STATE OF VERMONT
AGENCY OF TRANSPORTATION

RECORD PLANS

PROPOSED VERMONT 100

PROJECT DESCRIPTION: PROJECT CONSISTS OF CONSTRUCTING A BRIDGE OVER LAMOILLE RIVER ALONG WITH APPROACH WORK FROM THE EXISTING BISHOP MARSHALL DRIVE TO BRIDGE STREET

SHEET 20A OF 123

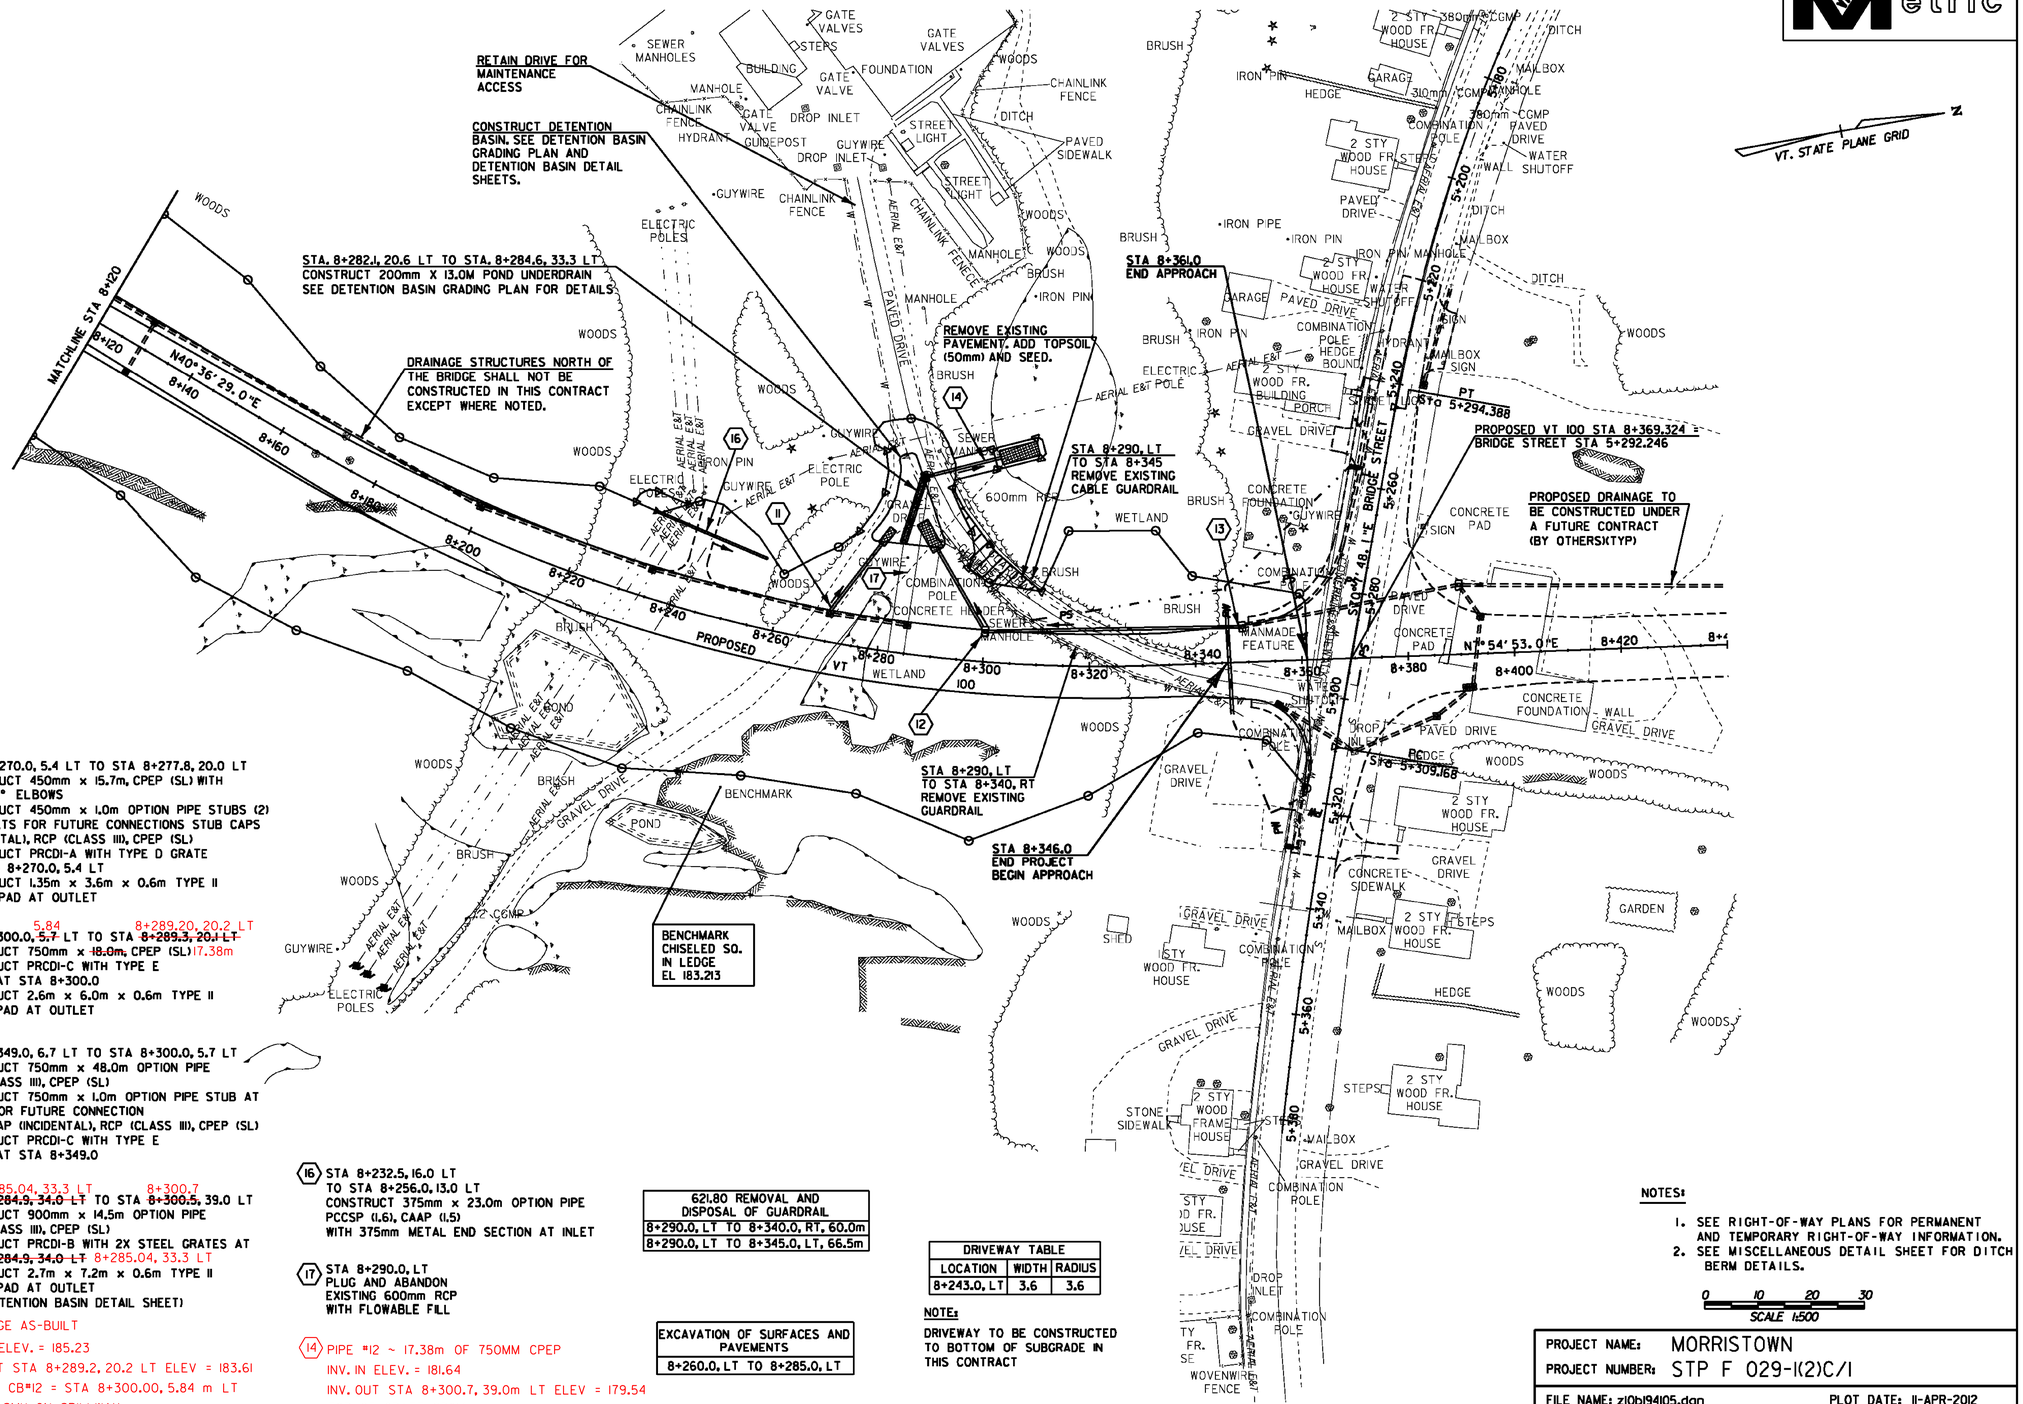
12 STA 8+300.0, ~~5.7~~ 5.84 LT TO STA ~~8+289.3, 20.1 LT~~ 8+289.20, 20.2 LT
CONSTRUCT 750mm x ~~18.0m~~ 17.38m CPEP (SL)
CONSTRUCT PRCDI-C WITH TYPE E GRATE AT STA 8+300.0
CONSTRUCT 2.6m x 6.0m x 0.6m TYPE II STONE PAD AT OUTLET

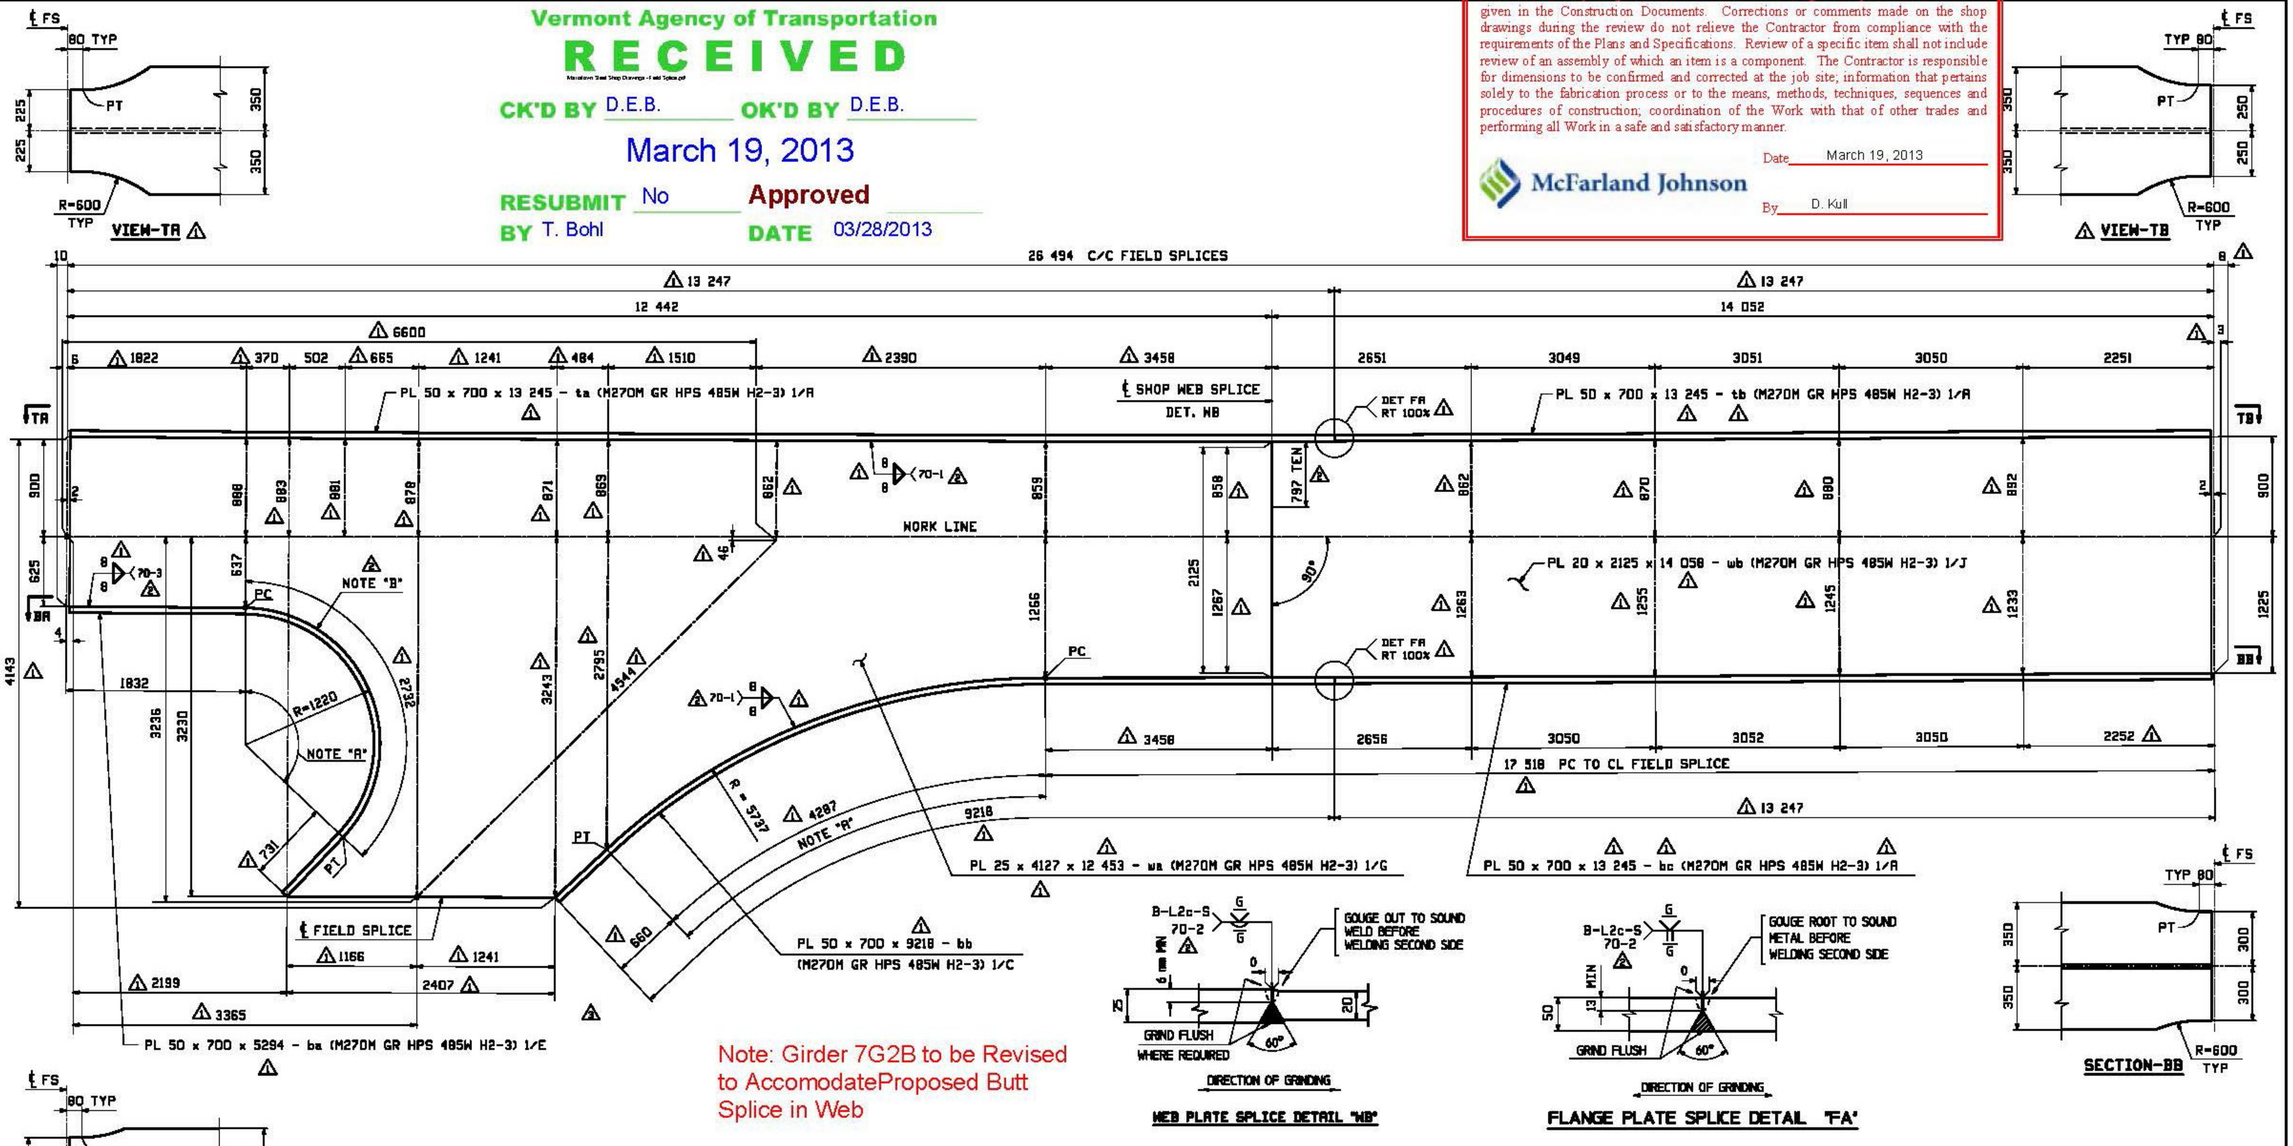
Note: Girder 7G2B to be Revised to AccomodateProposed Butt Splice in Web

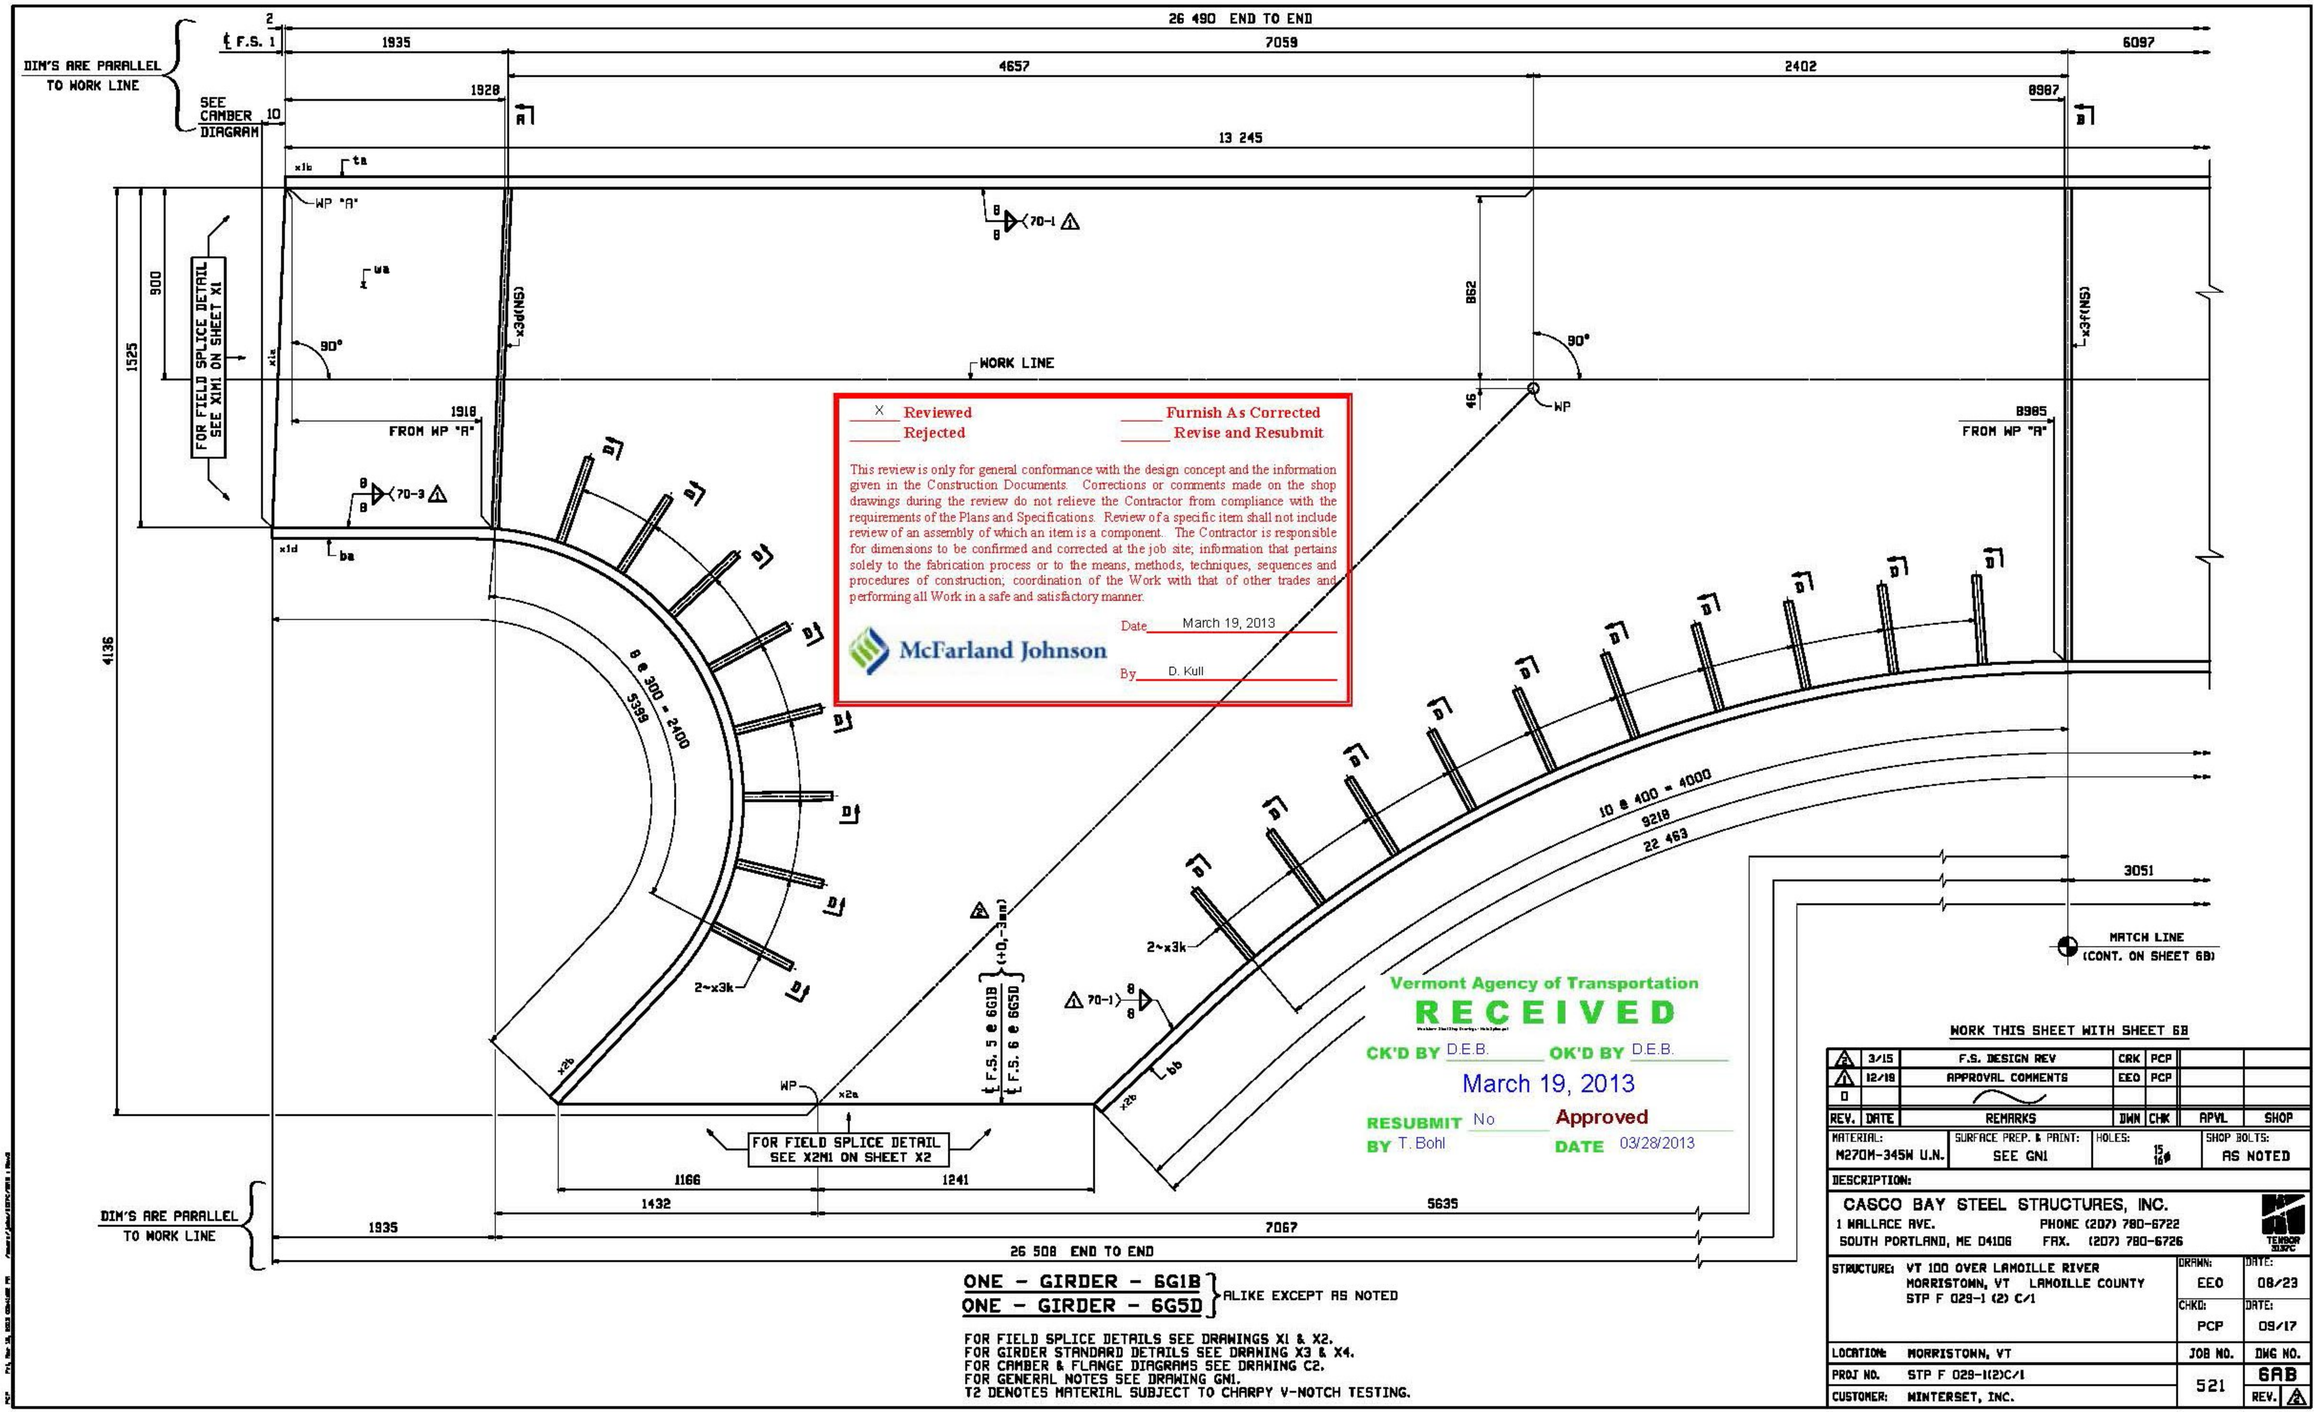
X Reviewed — Furnish As Corrected
Rejected — Revise and Resubmit
